Access Compliance Report

Public Rights-of-Way

Intersection ID: 26112	Main Street: COLONIAL HEIGHTS_DR	Cross Street: ELM_LN	Location: NW
ADA ID: 240DE674A3BB	Ramp Type: Para	Initial Pass/Fail: Fail	Overall Compliance: No
Codes/Mitigation Info/Possible Solution		Field Measurements/Component Compliance	
Severity Score: 31.25

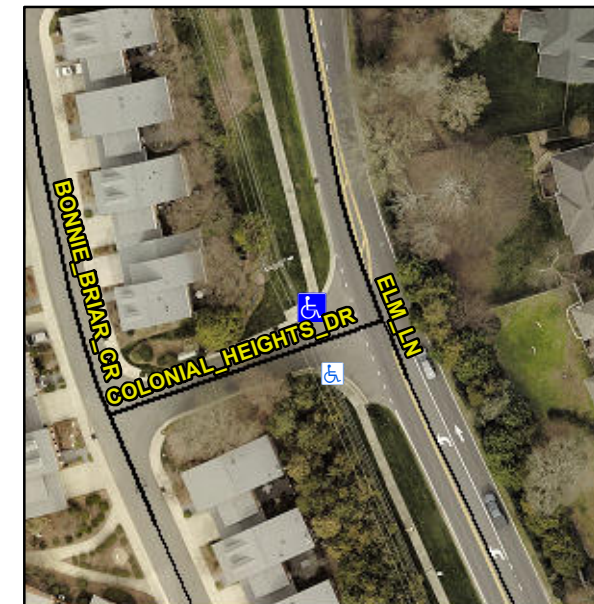
RT RP < 5%

R304.5.1, R304.3.2, R304.5.3

Remove & Replace Entire Ramp.
